SUBJECT: OCONEE NUCLEAR STATION, UNITS 1, 2 AND 3 RE: FINAL ACCIDENT SEQUENCE PRECURSOR ANALYSIS OF OPERATIONAL CONDITION

**LER No. 269/98-004**

Event Description: Calibration and calculational errors compromise emergency core cooling system transfer to emergency sump

**Licensee Comments**

Fig. 4 Event tree for medium-break LOCAs at Oconee.

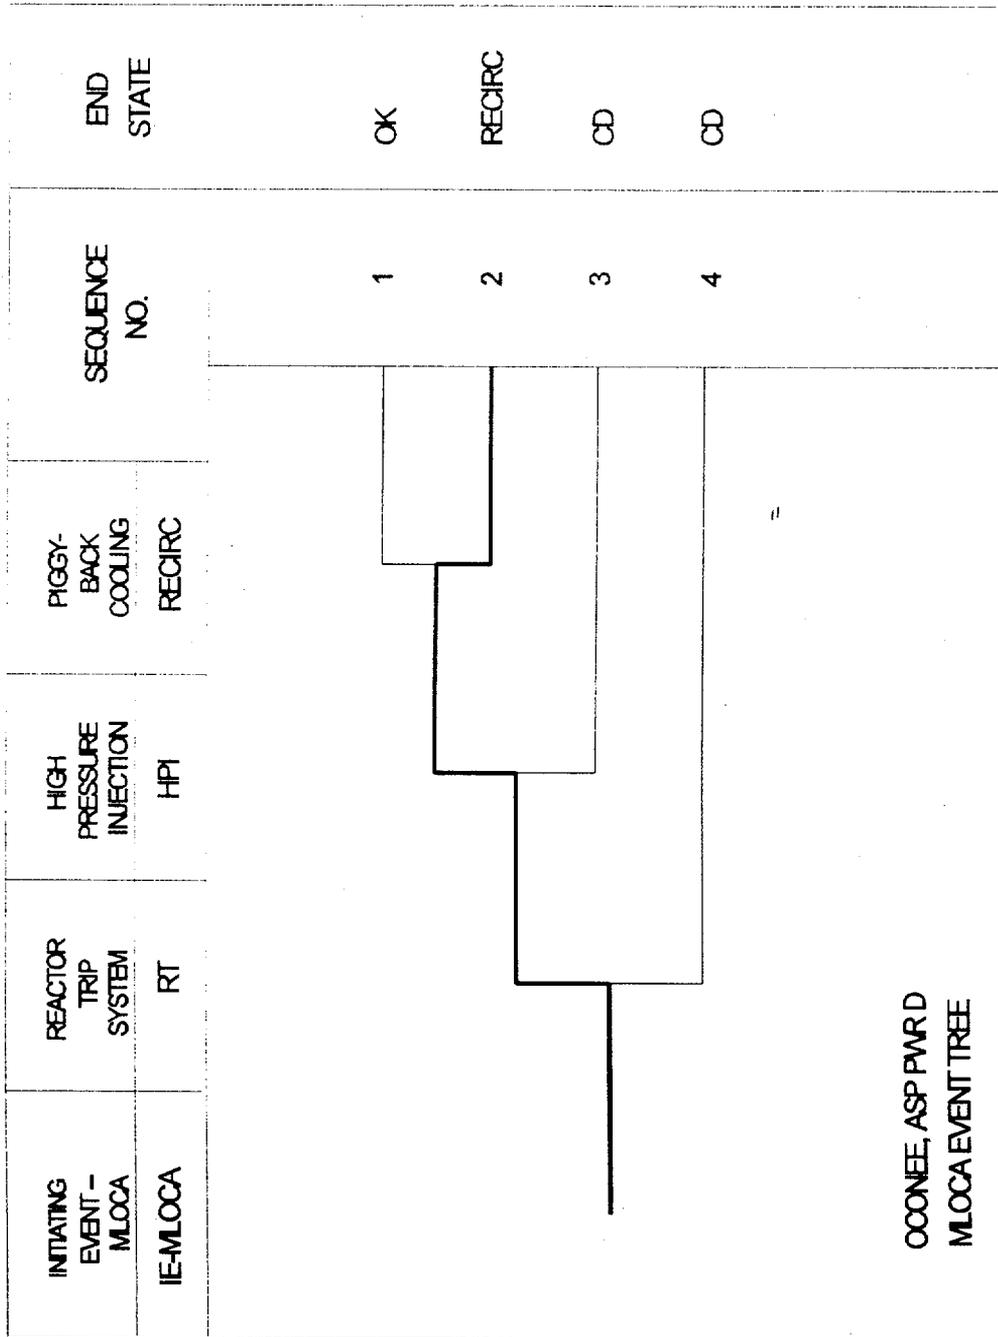
**Comment 1b:** The ORNL precursor evaluation assumed a nonrecovery probability of 0.5 for the medium LOCA cases. Such an assumption implies complete uncertainty in the success potential. A more optimistic view for the recovery potential is appropriate for the following reasons.

1. For the medium-break LOCAs, ~90 min is required to deplete the BWST inventory. The time to significant core heatup following the loss of injection should be longer than for the large LOCA case discussed previously. The time available for evaluation is sufficient to establish a reasonable understanding of the nature of the events.
2. The TSC is expected to be available prior the loss of injection. Because the TSC will be in place during the important stages of the event, their evaluation is more likely to be rapid and correct. The availability of the TSC is expected to aid the control room in determining the appropriate action.
3. Considerations of break size and location that are not the most limiting would also contribute to a higher likelihood of success.

The availability of the TSC to monitor the accident and assist in the diagnosis and decision making is expected to provide reasonable reliability in arriving at an appropriate course of action. Success under these conditions is likely, and a nonrecovery probability of 0.1 is judged to be a more appropriate value. The medium-break LOCA situation is judged to be similar to the small-break LOCA situation because of the TSC availability.

**Response 1b:** The availability of the TSC by the time that sump switchover is required following a medium-break LOCA is acknowledged, at least for day-time working hours. This availability would impact branch OPS-MIN as well as LPR-REC. Since LPR-REC is only demanded if the operators fail to effect transfer to the sump before the ECCS pumps fail, the TSC, if available, will have also failed to understand the event before pump failure. Considering the limited time available to recover recirculation (15 min based on the Oconee PRA description of LLP0P3CREC), the burden imposed by the unusual nature of the failure, and the expected difficulty in analyzing the nature of the failure,<sup>a</sup> a nonrecovery probability of 0.5 for LPR-REC (conditional on the failure of OPS-MIN) is considered appropriate and has been retained in the analysis. The intent was not to use 0.5 because there was complete uncertainty as to the recovery potential in a Bayesian sense, but to instead use the value because it was a reasonable estimate of the conditional probability that LPR would not be recovered, given that OPS-MIN had already failed.

The medium-break LOCA CCDPs, accounting for the unavailability of the TSC, are  $9.8 \times 10^{-7}$  for Units 1 and 2 and  $8.5 \times 10^{-7}$  for Unit 3; the overall CCDP for the event is  $1.7 \times 10^{-6}$

at Units 1 and 2 and  $1.4 \times 10^{-6}$  for Unit 3. To address the impact of the potential availability of the TSC by the time that sump switchover is required, the conditional core damage probability (CCDP) for a medium-break LOCA was recalculated assuming the TSC would be available for all medium-break LOCAs at the time sump switchover was required. The resulting medium-break LOCA CCDPs are  $6.5 \times 10^{-7}$  for Units 1 and 2 and  $8.2 \times 10^{-7}$  for Unit 3; the overall CCDP for the event reduces to  $1.3 \times 10^{-6}$  at each unit. The **Analysis Results** has been revised to describe this result as a sensitivity analysis.

Fig. 5 Event tree for failure to transfer the emergency core cooling system pumps to the reactor building emergency sump (RBES). BWST is borated water storage tank.

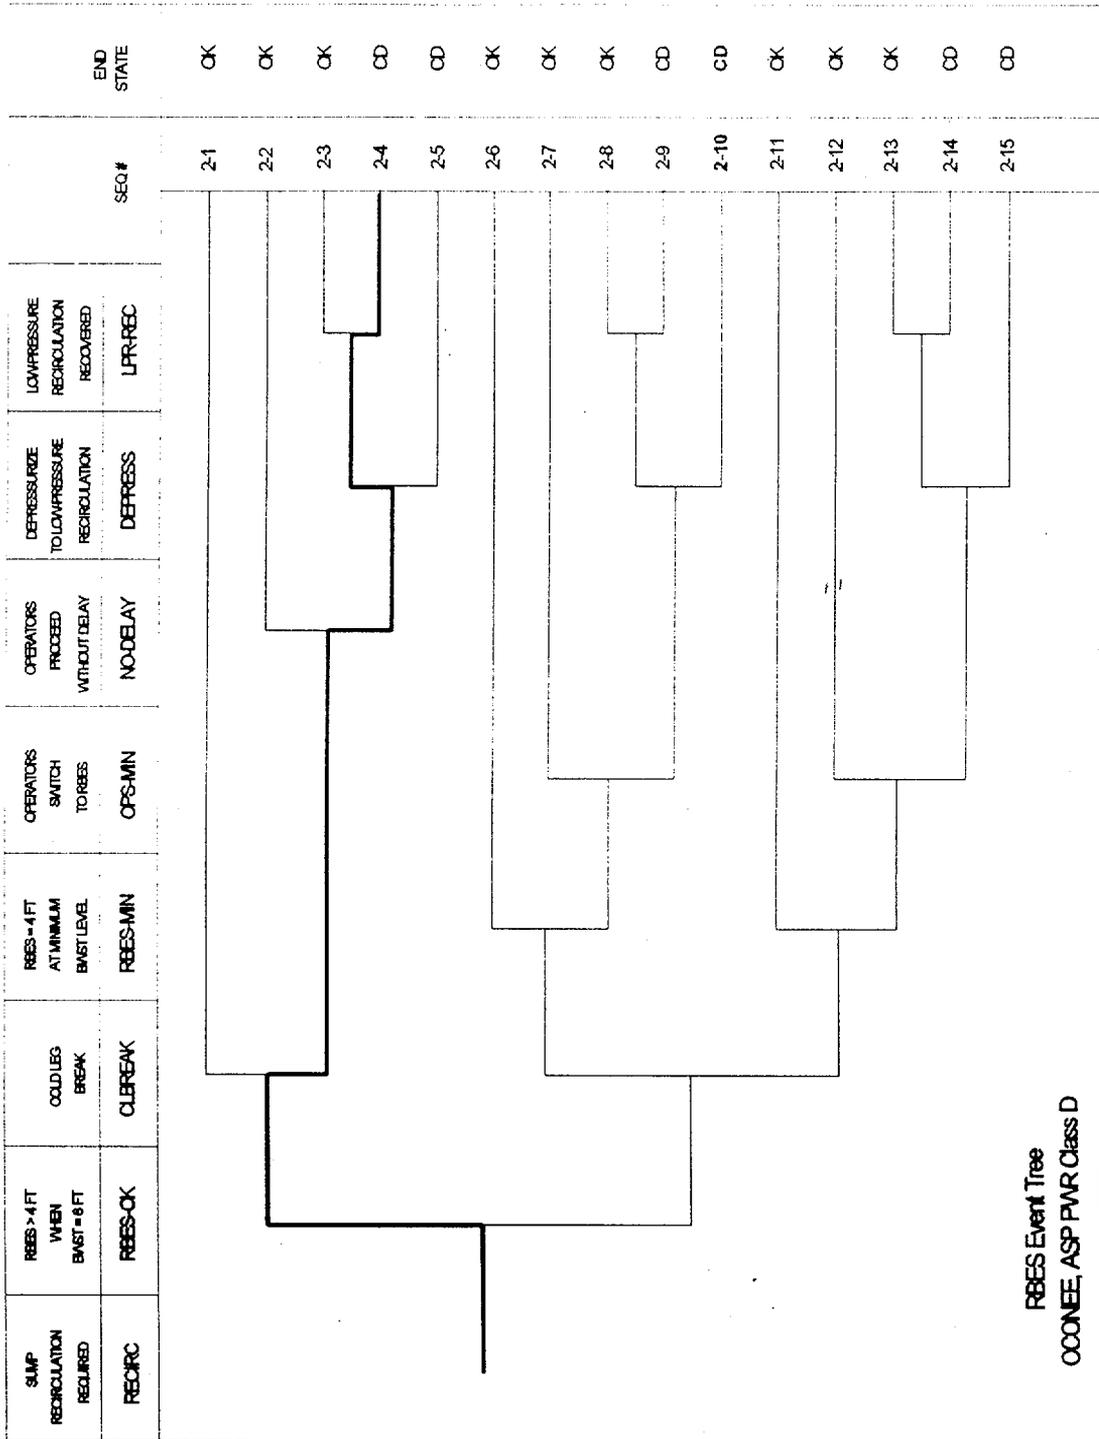
**Comment 1a:** The ORNL precursor evaluation assumed a nonrecovery probability of 1.0 for the large-break LOCA cases. Such an assumption implies complete certainty that the action will fail. A failure probability of 1.0 seems pessimistic for the following reasons.

1. Based on the RELAP and MAAP simulations, it is estimated that at least 30 min are available following the loss of coolant injection before core damage would begin. While there would certainly be some concern over the cause of failure of the previously operating low-pressure injection (LPI) pumps, it is also clear that inaction will lead to core damage [the inadequate core cooling section of the emergency procedure (EP) will be entered following core uncover]. Given that aligning the C LPI pump requires only a few minutes, at least 30 min are expected to be available for evaluation on the situation.
2. Significant core damage is not expected for more than 1 h following the initiation of the LOCA. The technical support center (TSC), or at least some of the TSC staff, should be available to assist in the evaluation.

3. These timing estimates assume a very large break at the horizontal portion of the hot leg. Breaks at locations higher than the horizontal run of the hot leg will provide significantly more liquid inventory in the reactor coolant system (RCS) at the time that coolant injection is lost and extend the time to significant core heatup. Breaks at the small end of the large-break LOCA range may also afford additional time.

For these reasons, we feel that a value of 1.0 for the nonrecovery probability reflects a degree of certainty that is not appropriate. A value of 0.5 for the nonrecovery probability would be indicative of complete uncertainty in the recovery potential, reflecting neither a pessimistic nor optimistic bias in the assumed recovery potential. A value of 0.5 is a more appropriate (but possibly conservative) selection for the nonrecovery probability.

**Response 1a:** A nonrecovery probability of 1.0 was used for LPR-REC following a large-break LOCA because once the LPI pumps had failed, the short amount of time available would not support diagnosis and alignment of the third LPI pump. The models used for ASP analyses assume an undesirable end state when core uncover occurs (see Appendix B to *Precursors to Potential Severe Core Damage, 1994, A Status Report*, NUREG/CR-4674, Vol. 21, December 1995). The LER reporting this event estimates core uncover to occur about 7 min after the loss of low-pressure injection. The Oconee 3 Probabilistic Risk Assessment (PRA), Rev. 1, includes a 10-min time period to diagnose a loss of LPI and start and align LPI pump C (basic event LLP0P3CREC in the Oconee PRA) following the typical pump and valve failures addressed in the PRA.

In the modeling of this event, LPR-REC is applied only after the operators have failed to recognize the need to swap suction to the sump as the water level in the BWST continues to decrease, resulting in the failure of the LPI pump. As noted in **Modeling Assumptions**, operator burden (associated with the unusual nature of the instrumentation anomalies in addition to the existence of the large-break LOCA) plus annunciator noise would be expected to delay the operating crew's realization that the LPI pumps had failed and delay diagnosis of the failure and implementation of any recovery strategy until well beyond the time that core uncover occurs, even if the large-break LOCA is somewhat smaller than double-ended or occurs at a more advantageous location in the hot leg. For this reason, a nonrecovery probability of 1.0 is considered appropriate for LPR-REC for a large-break LOCA and has been retained in the analysis. **Modeling Assumptions** has been expanded to provide additional detail concerning the assumption of 1.0 for the nonrecovery probability of LPR-REC.
